SIXTH DEGREE TOWNHOMES

MAJ-25-0002, 121 E Main Street Sixth Degree Town Homes Sketch Plan

RE: Comments on preliminary plans for 6th Degree Townhomes at 121 Main St, Frisco, CO

Marcin Engineering has reviewed the comments received from the Town of Frisco on the preliminary plans for 6th Degree Townhomes at 121 Main St in Frisco, CO dated 11/28/2025, and has updated the design plans accordingly. Each written comment on the plans was provided with a response, outlined below. This document accompanies our design plans dated 01/23/2026.

SHEET
 C-1

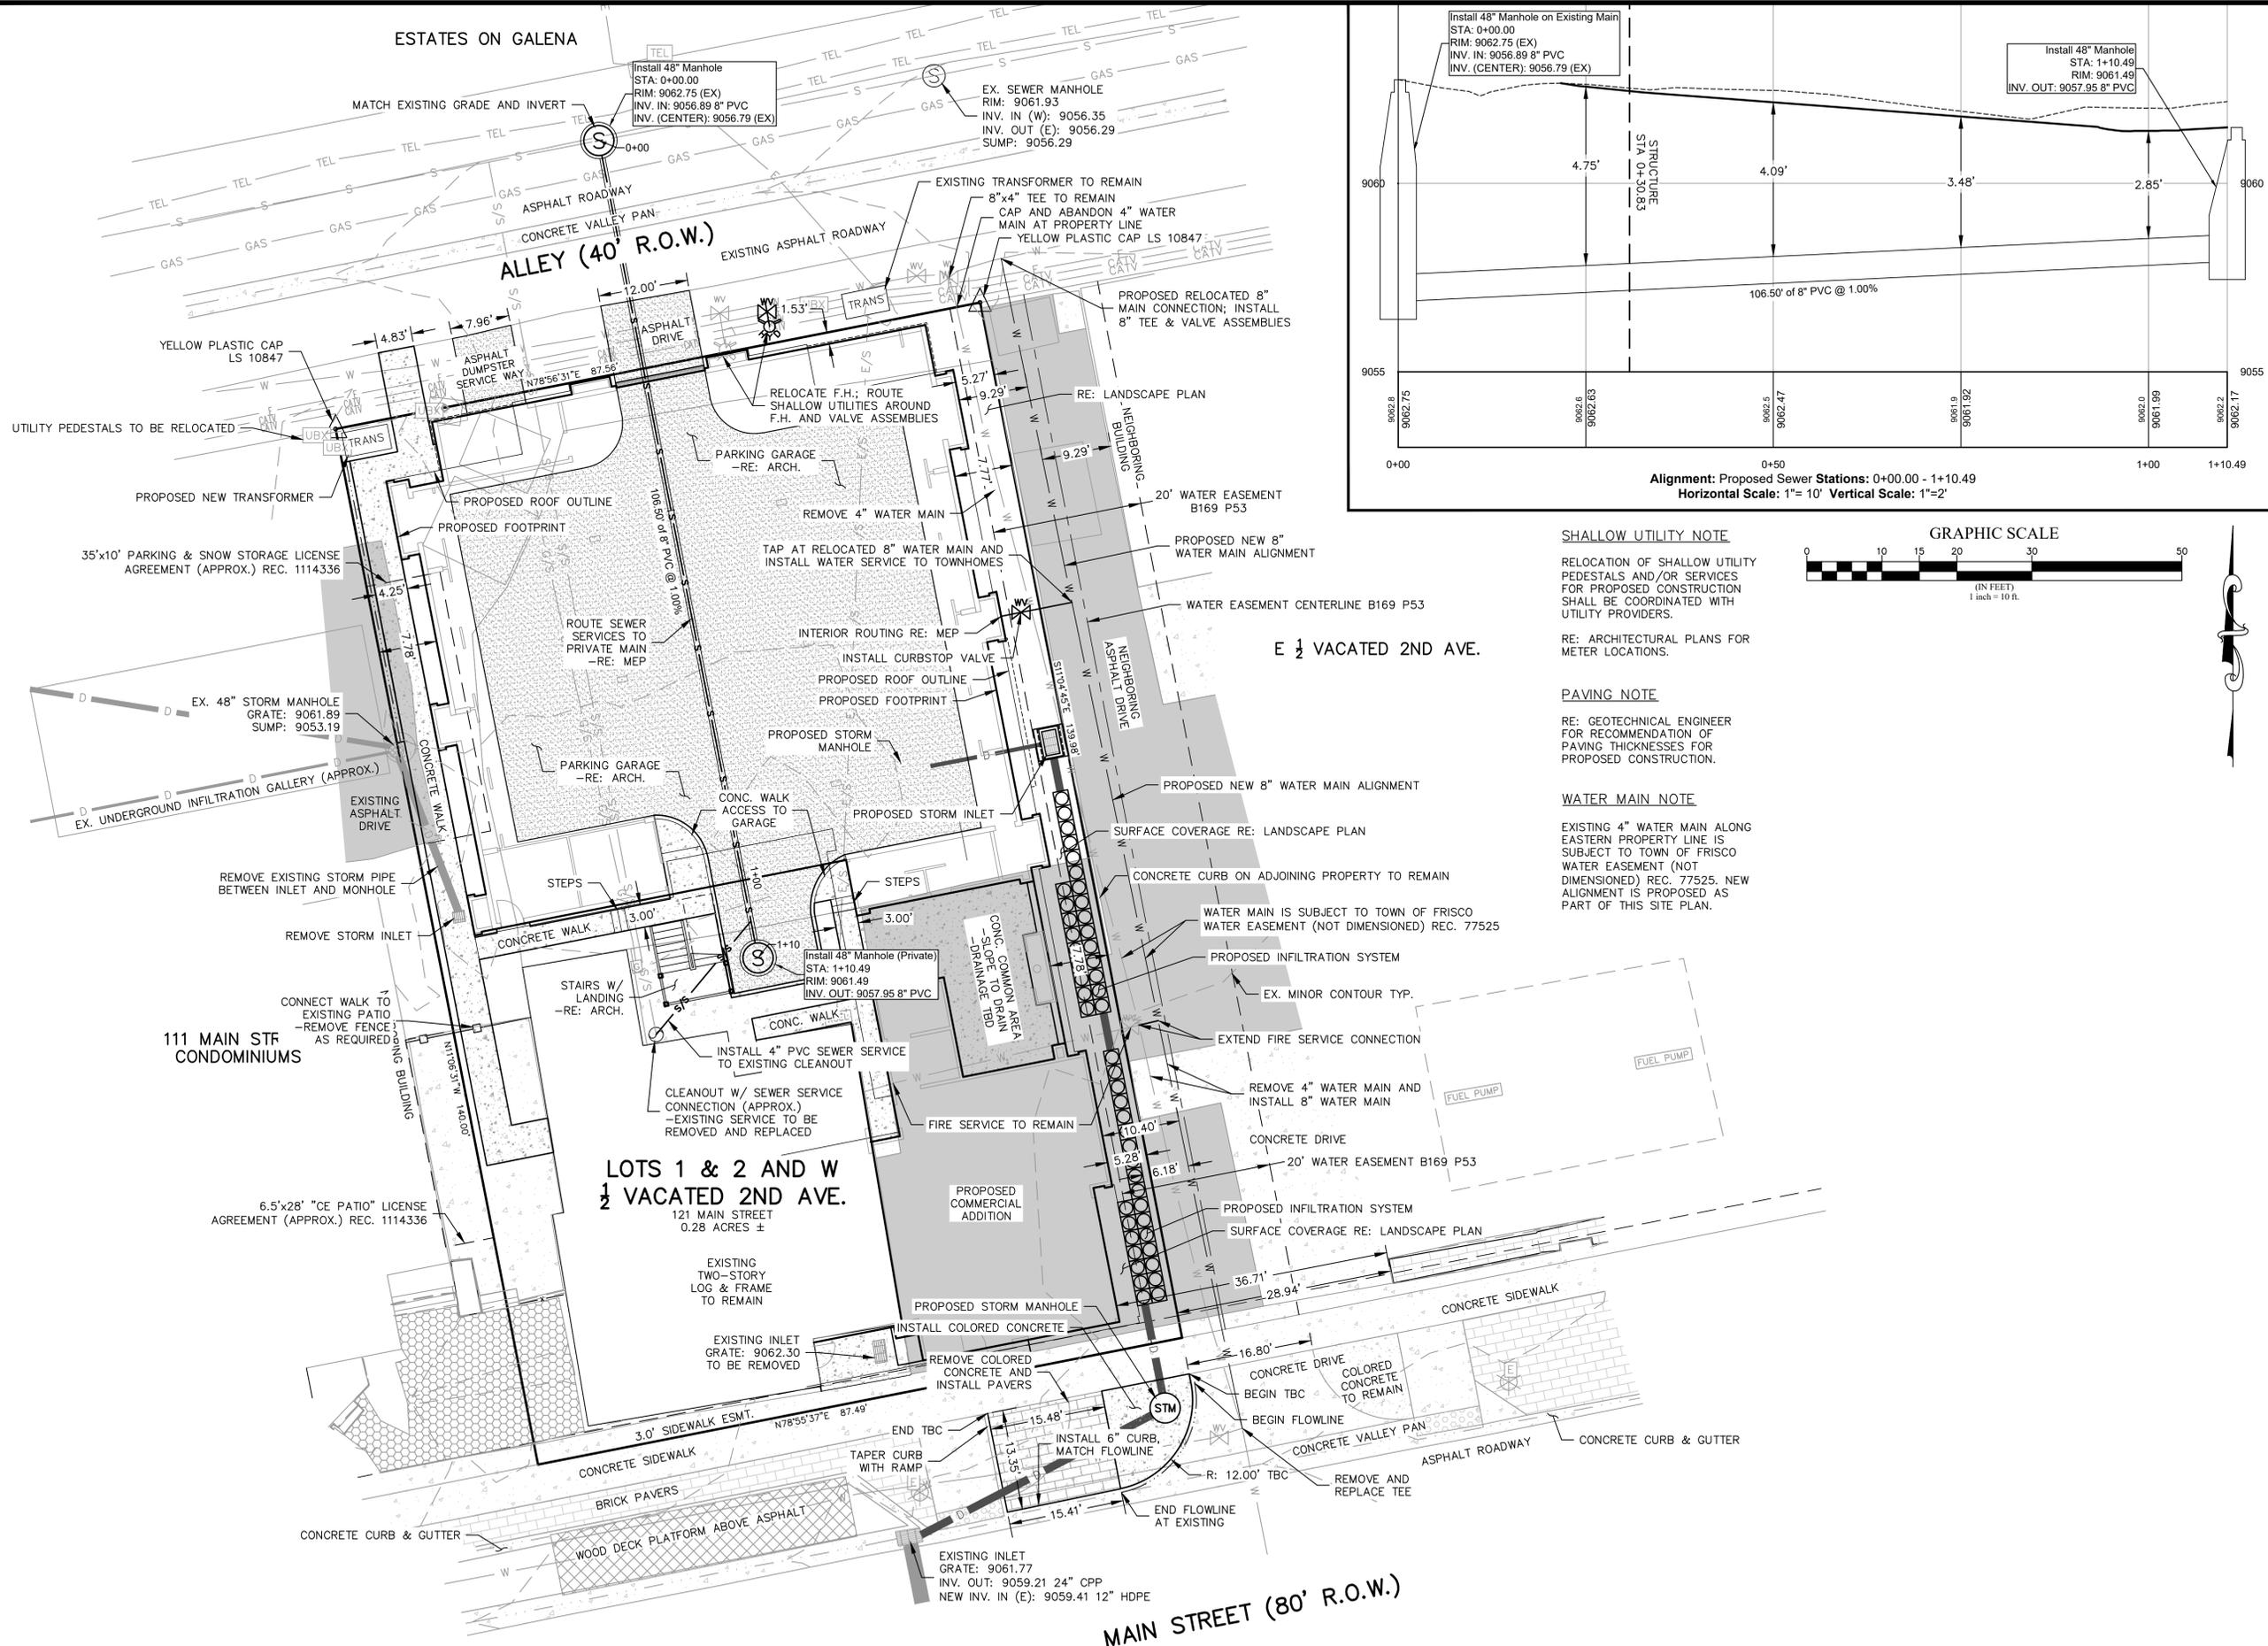
Comment: *Separation does not meet code. Needs to be included on waiver request. (Sheet C-1)*

Comment: *IFC requires 3’ clearance around hydrants in all directions. Adjust location. (Sheet C-1)*

Comment: *Existing line to be capped and abandoned. (Sheet C-1)*

Comment: *Show existing water easement to confirm alignment. (Sheet C-1)*

Comment: *Has there been a soils study? Will need to see additional drainage memo to confirm infiltration and proximity to foundation will not cause issues. (Sheet C-1)*

Comment: *Show existing colored concrete radius for driveway. Resulting width likely does not meet Town standards for commercial or IFC for two way commercial. Modify driveway to be symmetrical and meet width requirements (24’). May need to modify ramps and/or west side of driveway. One way entrance could help but not sure this is feasible for fuel truck operations. (Sheet C-1)*

Comment: *Need to show south side of intersection. These changes will turn intersection into an offset/skewed intersection instead of a four way ninety degree intersections. Needs to be detailed further and analyzed. Exiting vehicles will be aligned with oncoming NB traffic from 2nd Ave. See screenshot above for approximation of driveway issue. (Sheet C-1)*

Comment: *Show pipe out. (Sheet C-1)*

Response: The asphalt ramp to the dumpster enclosure is now referred to as a “service way” rather than a driveway.

Response: This hydrant has been shifted 2’ farther east to achieve the 3’ clearance requirement.

Response: A note about this has been added accordingly.

Response: The water easement is now included in the plans.

Response: We have referenced the soil study done for this property and set the base elevation of this system above the observed groundwater elevation at the nearest bore hole at the time of the study. The anticipated foundation type is slab on grade rather than crawlspace. **See added detail on C-1 (Section A-A)**

Response: The colored concrete portion is now shown on the plans with dimensions confirming the effective access width. In the existing condition, the gas station access is only wide enough due to pavement covering portions of the subject property. To the best of our knowledge, there is no easement making the existing access width official. The gas station should expand the access

width on their end if it is not wide enough for the Town to approve. **It should also be noted that the current fuel truck operation would not be impacted by the revised width based on the attached observations.**

Response: Along with our plan updates, an exhibit showing the intersection with the proposed access width of the gas station is included. While there is an offset, it does not appear to be extreme. Since the access is for the gas station, the access should be confined to the gas station property as it is platted today.

Response: This pipe is now shown in the background for the plans.

SHEET C-2

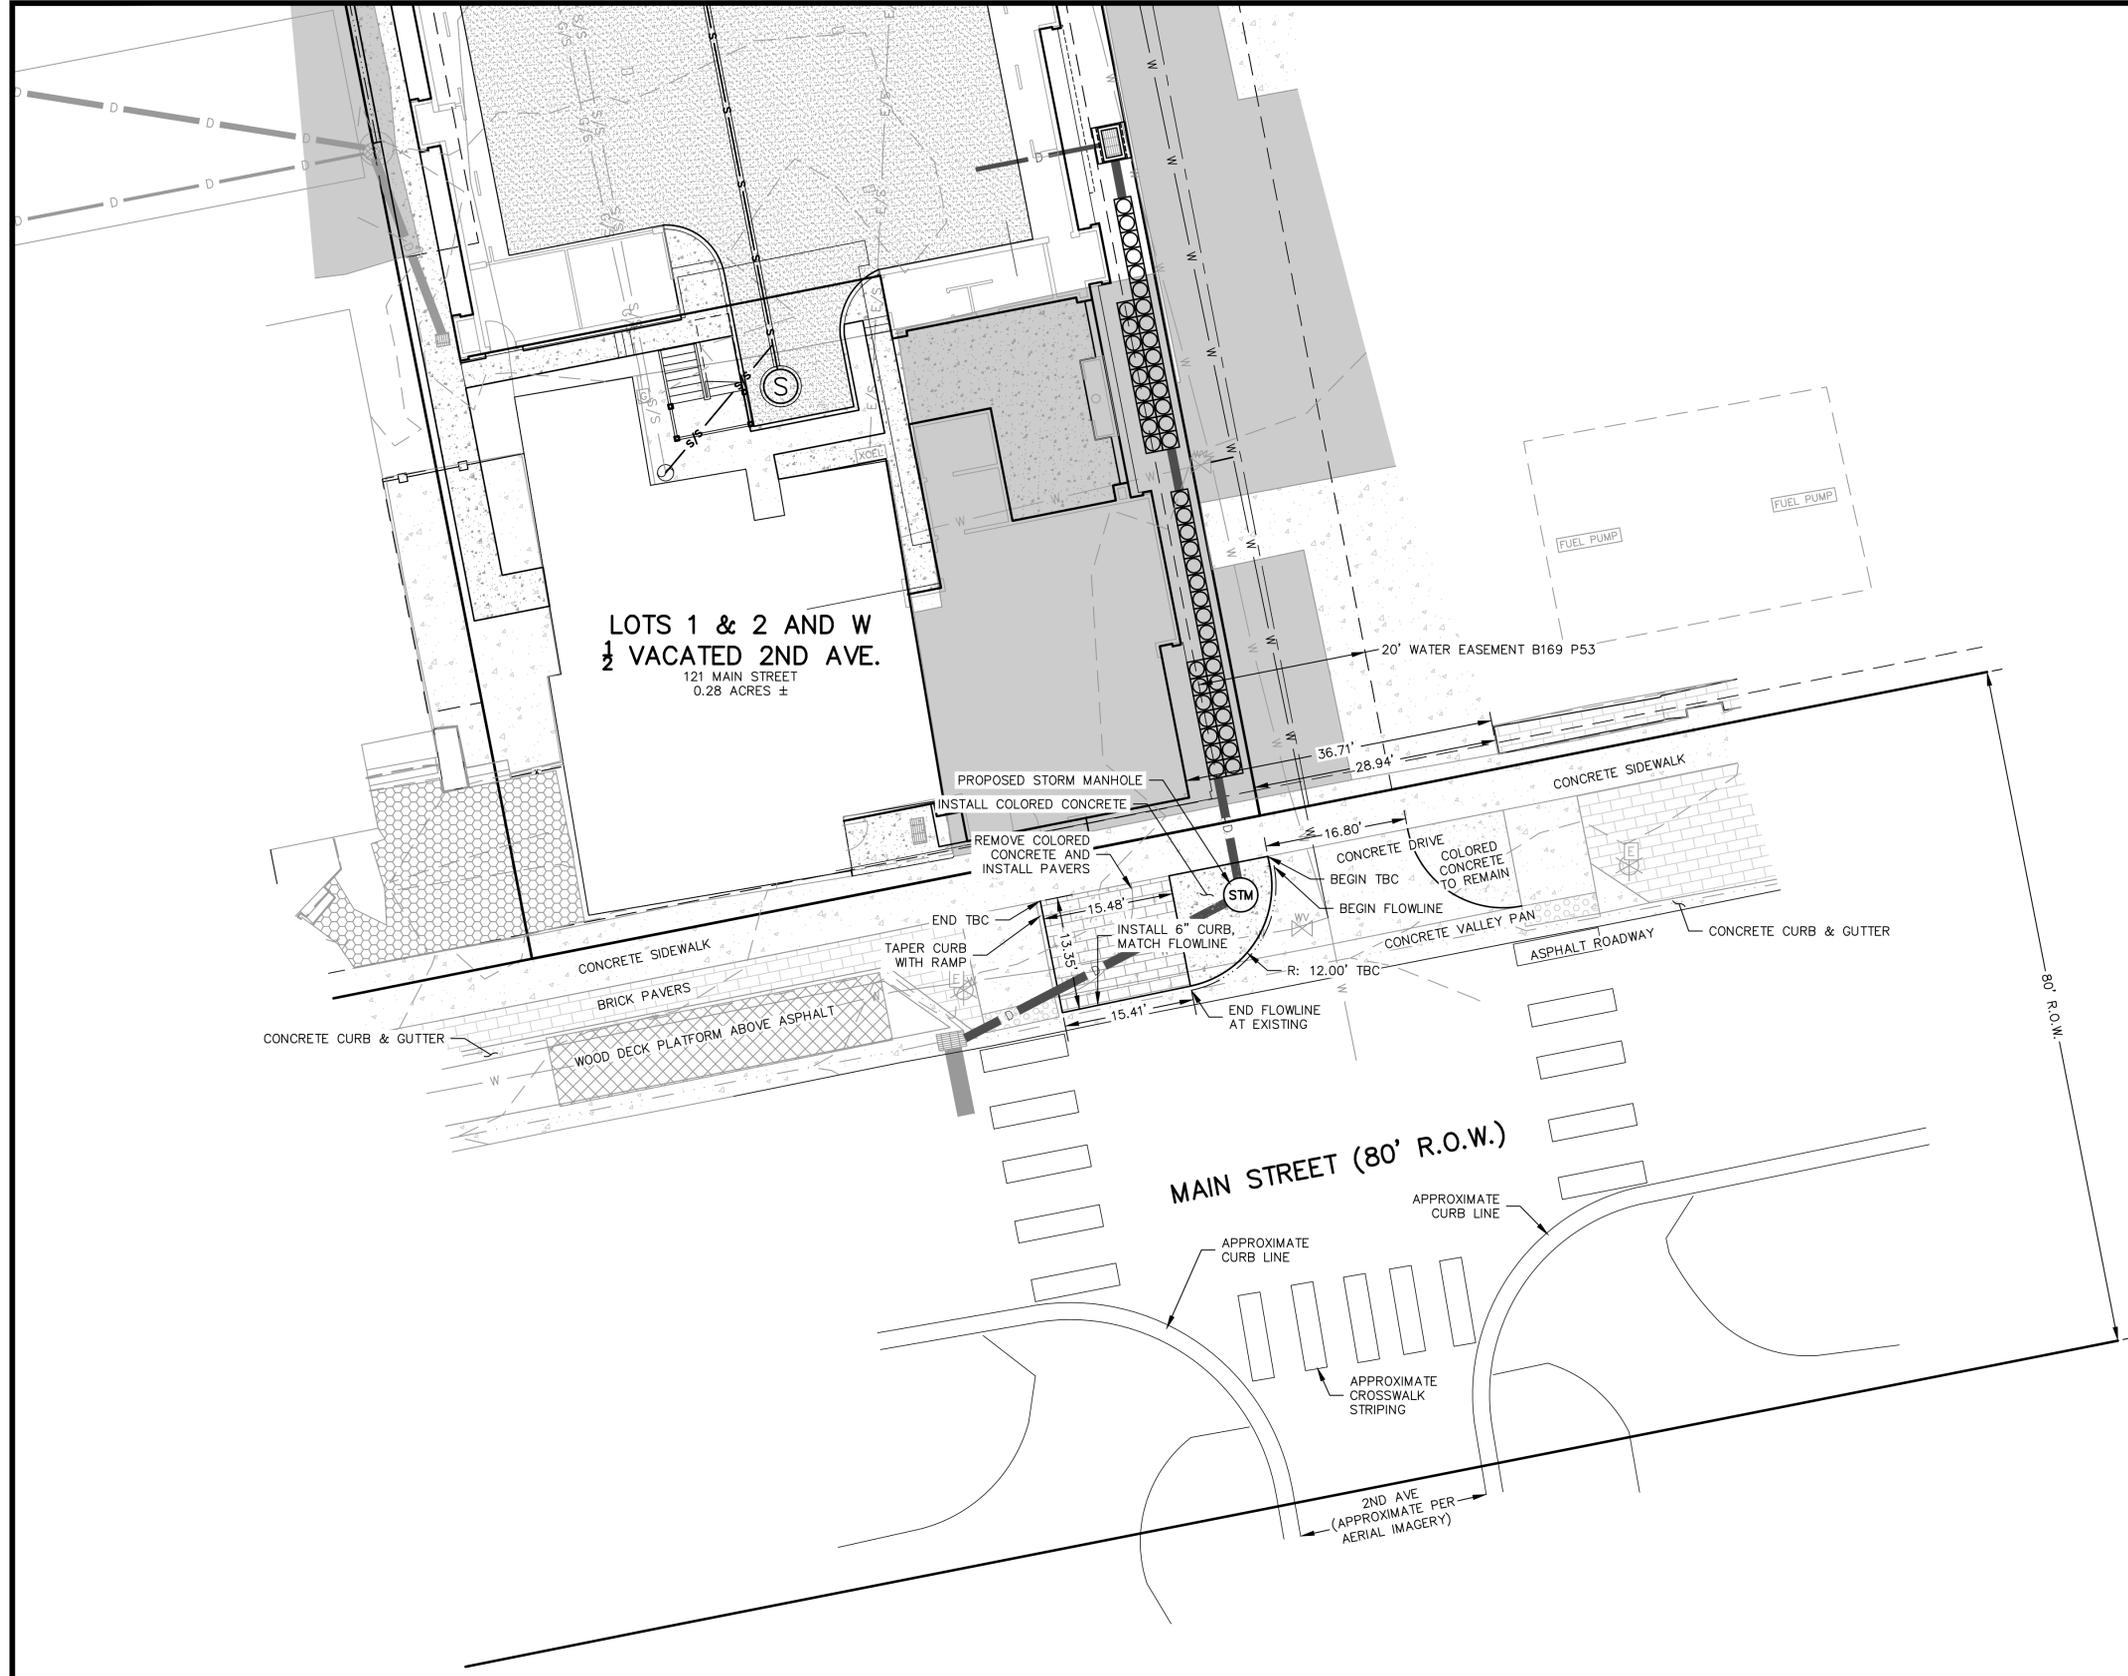
Comment: *1' is narrow to grade a swale. Consider a narrow concrete pan. (Sheet C-2)*

Comment: *1.0' (Sheet C-2)*

Comment: *Does not meet ADA. Adjust to 5% or less. (Sheet C-2)*

Comment: *Show ramp reconstruction for storm install. (Sheet C-2)*

Comment: *Invert out is 58.15 but invert out of storm inlet on Main Street is 59.21. Elevations result in a sump condition of pipe. Cover on storm line will likely be very minimal and below standards for HDPE. Concrete pipe likely required. Sheet C-2)*

Response: Acknowledged. We now propose a narrow concrete pan for this area.

Response: This dimension has been fixed.

Response: We have re-graded this area to be less than 5% in slope.

Response: We have added a note here to address that the ramp shall be reconstructed to its original condition upon the installation of the storm sewer.

Response: We now propose concrete pipes for this storm system. We acknowledge that the storm system proposes a sump situation, however, with the shallow condition of the only storm system connection available in this area, it is the only feasible direction to accomplish installing an underground infiltration system on a tight site. We also now propose that connections to the infiltration system happen outside of the building footprint due to the sump condition of the infiltration system.
